APPLICATION TO THE ZONING BOARD OF ADJUSTMENT

Denial Memorandum

Applicant: Patrick Armstrong
Property Address: 2 Oyster Bay Drive, Rumson, NJ 07760
Block, Lot & Zone: Block 128, Lot 6, Zone R-1

I have reviewed the Land Use & Development Permit application for the installation of an in-ground swimming pool and expansion of raised deck.

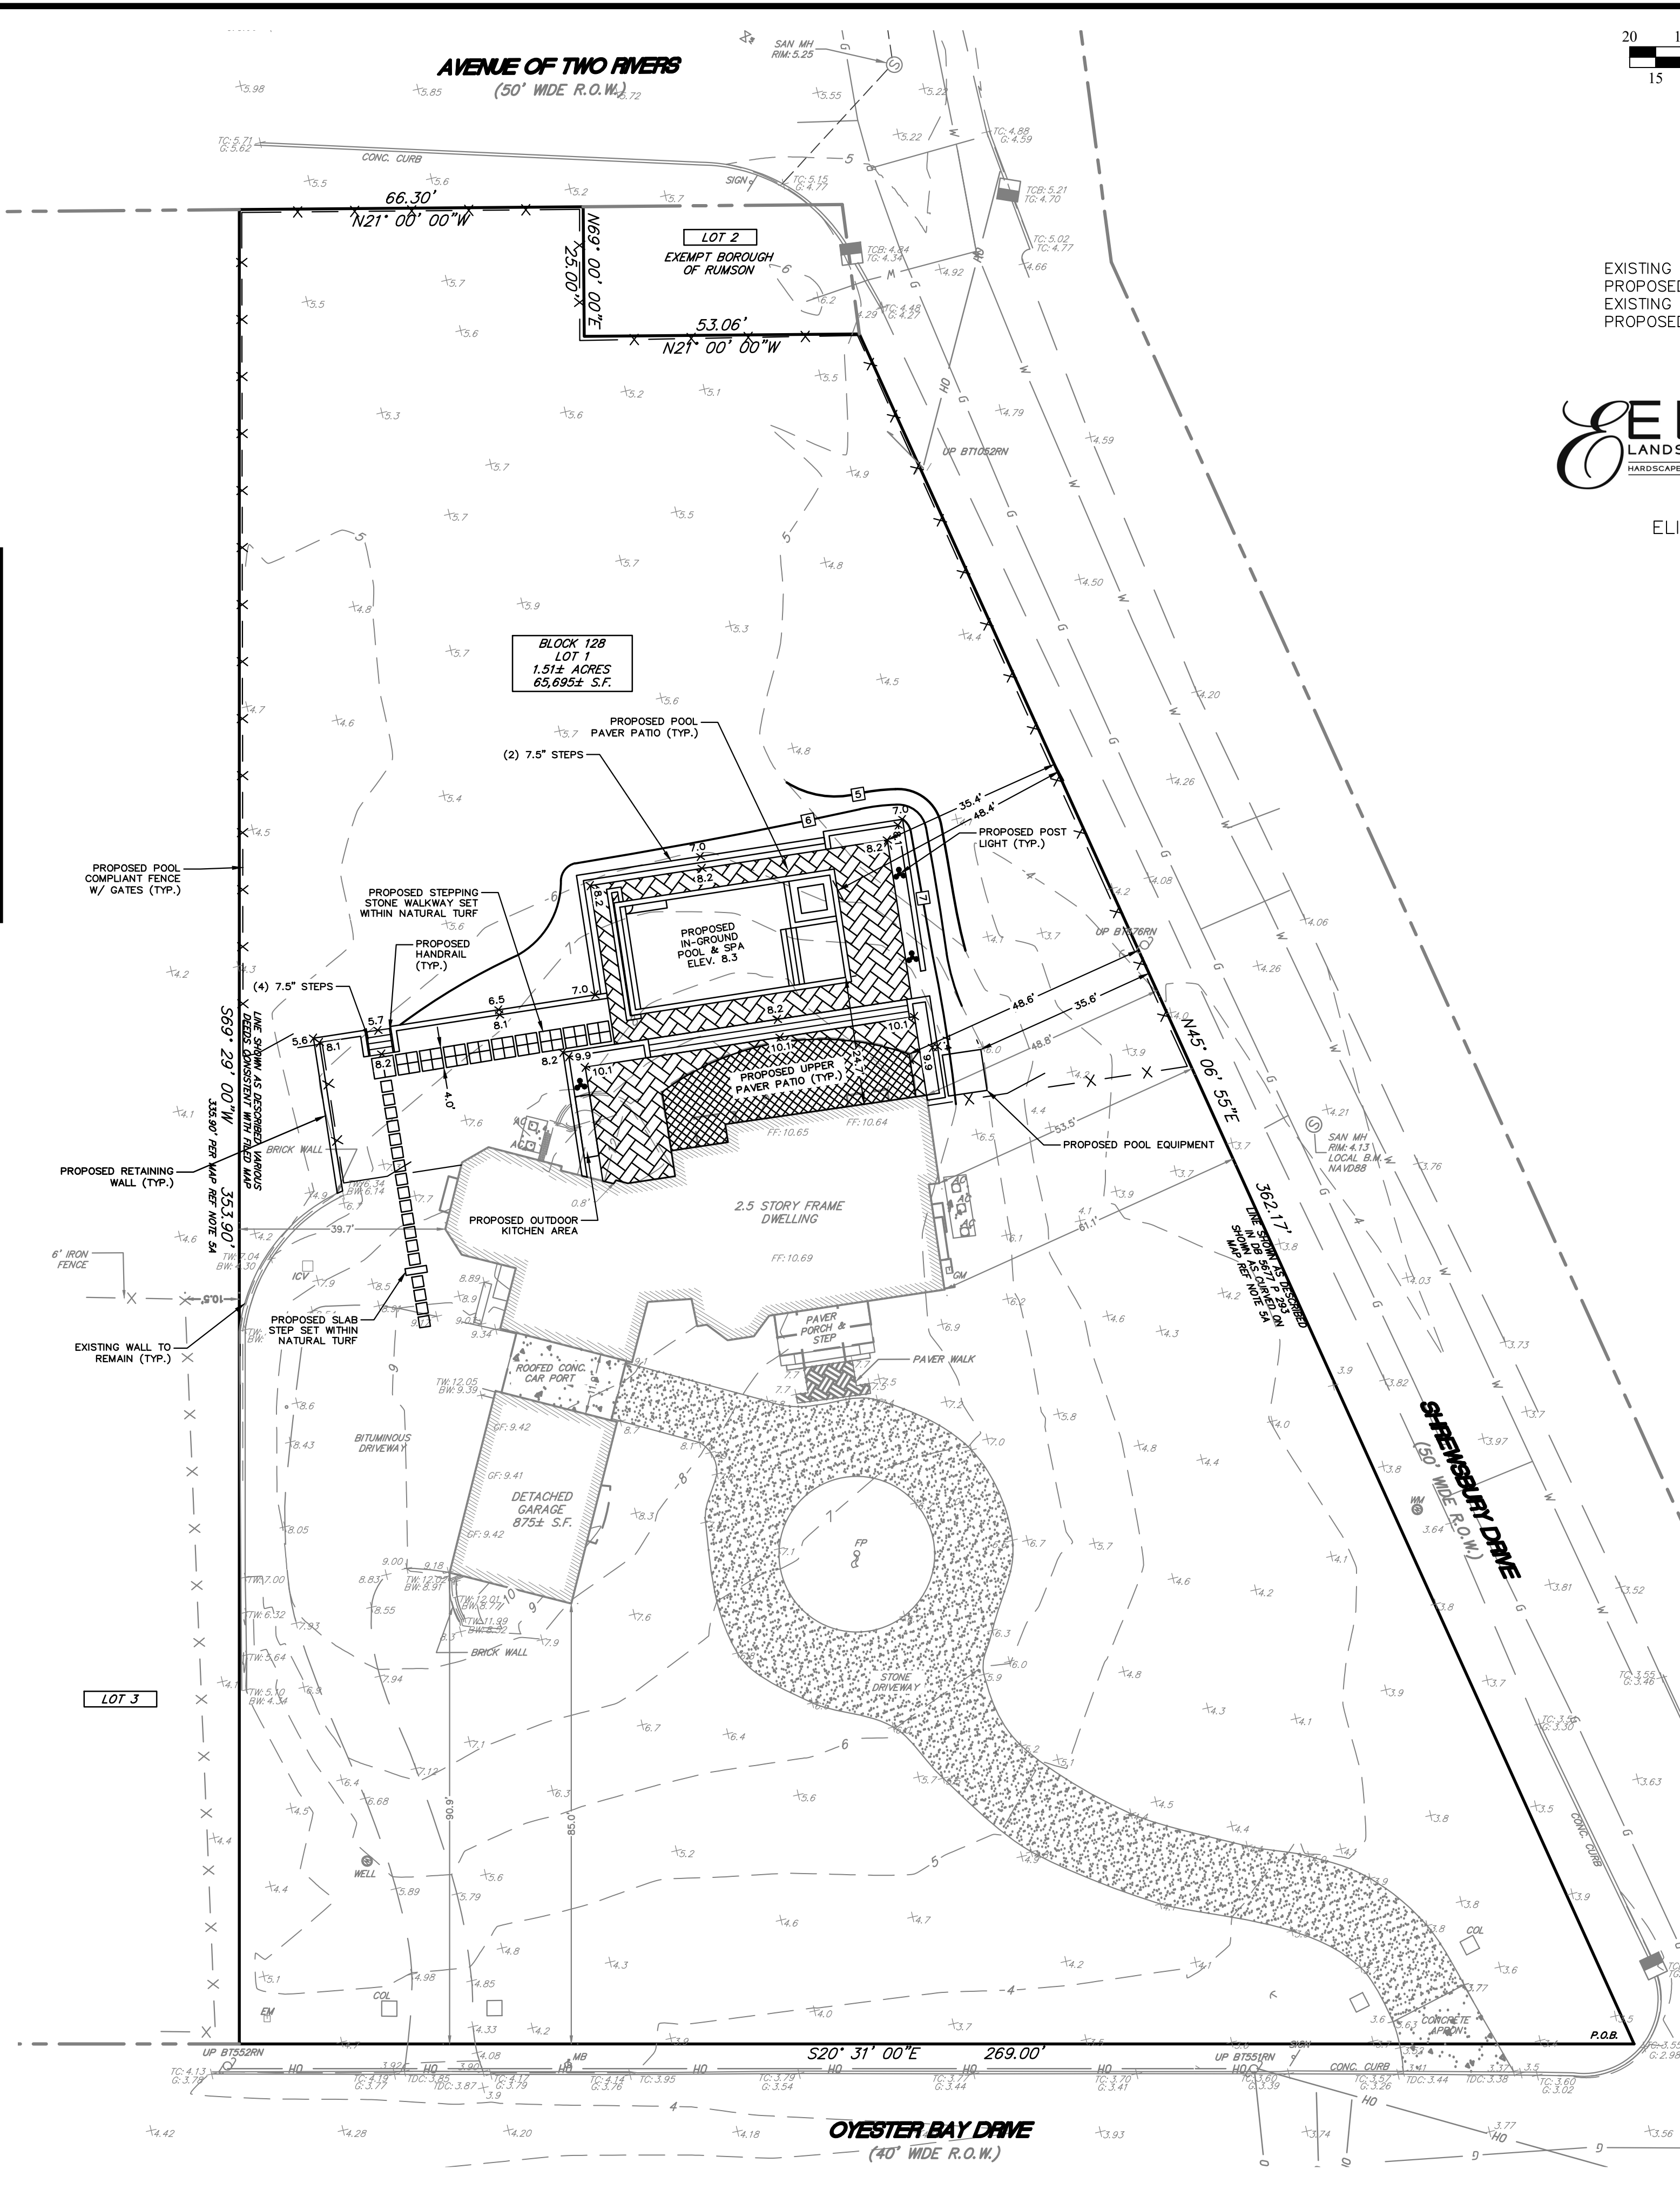
- Raised pool in the front yard setback
- Raised patio in the front yard setback
- The new, expanded covered porch and upper raised deck are in the front yard setback
- Accessory equipment (pool equipment and pole lights) in the front yard setback

Supporting documents include the Pool Grading Plan, signed and sealed by Kevin E. Shelly, P.E., dated April 23, 2025, no revisions, consisting of four sheets. Please correct the scale and add the setback lines on revised plans. Note that all accessory structures attached to the principal dwelling (without 5' separation) are required to meet the principal dwelling setbacks.
